# SERVICE BULLETIN

MODEL BD-700-1A10 (BD-700)

## MODIFICATION – RADIO ALTIMETER SYSTEM – RADIO ALTIMETER ANTENNA CORROSION PROTECTION

**KGC991-1134**  
 Kit -Radio Altimeter Corrosion Protection  
 (Sheet 1 of 2, Rev B)

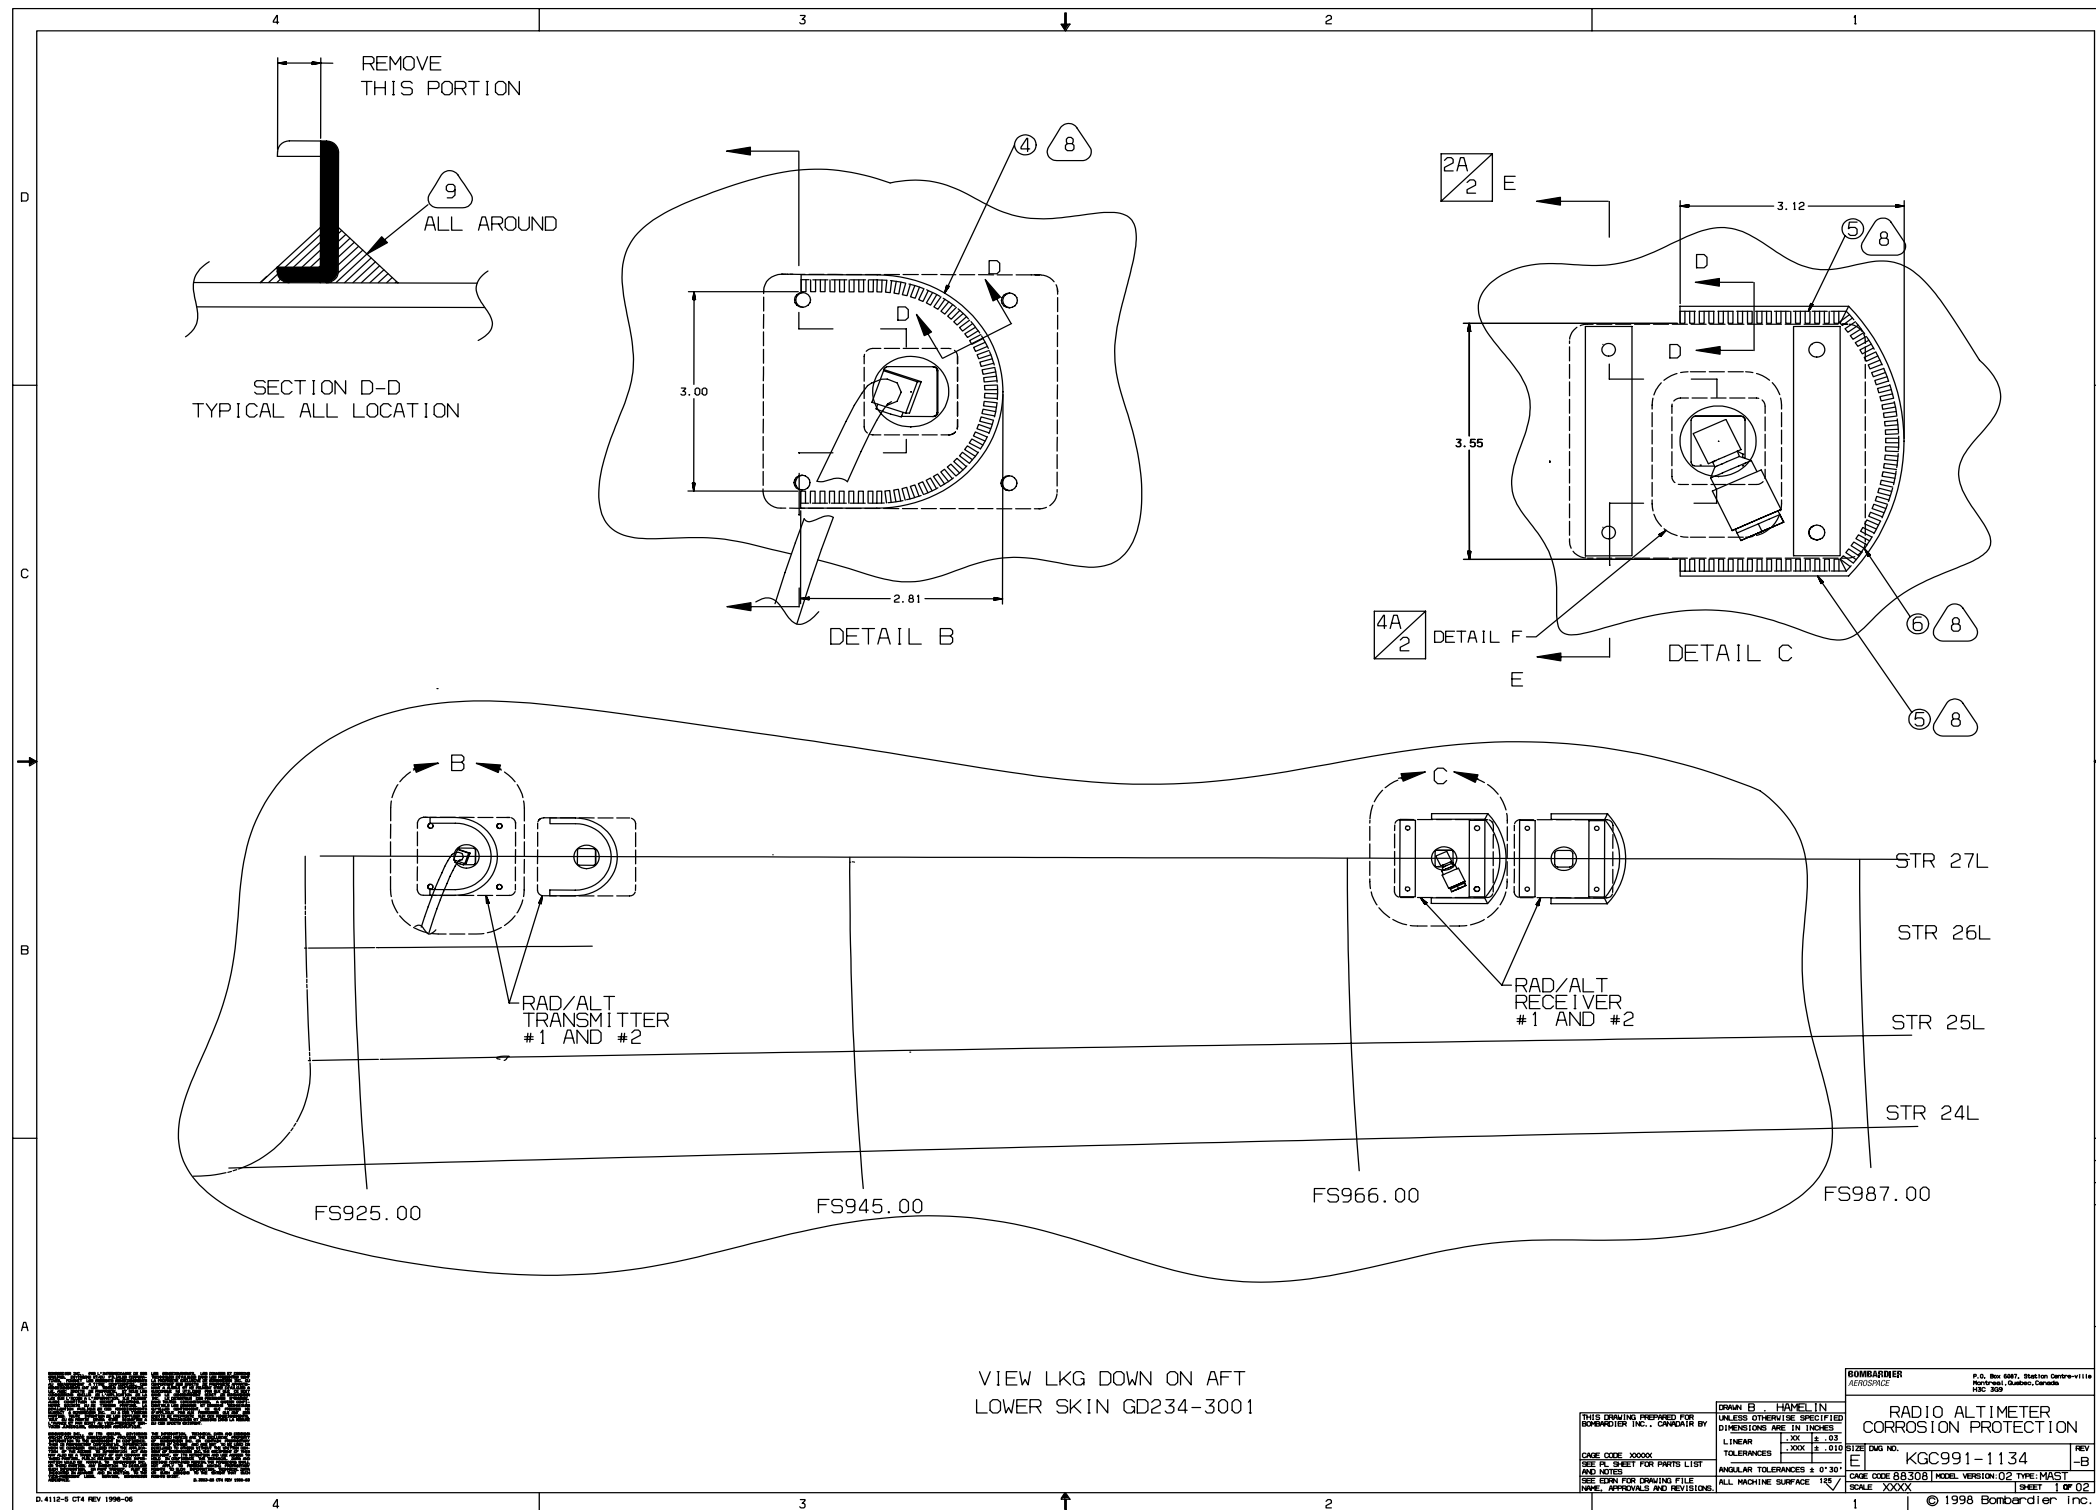
- (6) Rework the adapter plates, Part No. GD517-4352-1 for the radio altimeter receiver antennas as given in Kit Drawing KGC991-1134.
- (7) Re-identify reworked parts as KGC991-1134-3.

- (8) Rework the adapter plates, Part No. GD517-4351-1 for the radio altimeter transmitter antennas as given in Kit Drawing KGC991-1134.
- (9) Re-identify reworked parts as KGC991-1134-11.

- (10) Install a new packing, Part No. M25988/1-025 on each receiver antenna.
- (11) Install the self-sealing contour pads on the receiver antennas between the antennas, adapter plates and the aircraft skin. Refer to AMM, TASK 51-23-00-390-821 and to Kit Drawing KGC991-1134.

- (14) Install the self-sealing contour pads on the radio altimeter transmitter antennas between the antennas, adapter plates and access panel, Part No. GD297-1500-9. Refer to AMM, TASK 51-23-00-390-821 and to Kit Drawing KGC991-1134.

- (15) Make the water dam with the raw material, Part No. MS21266-8N provided in the kit. Refer to Kit Drawing KGC991-1134.

- (16) Install the water dam on the transmitter and receiver antennas. Refer to TASK 51-21-21-340-801 and to Kit Drawing KGC991-1134.
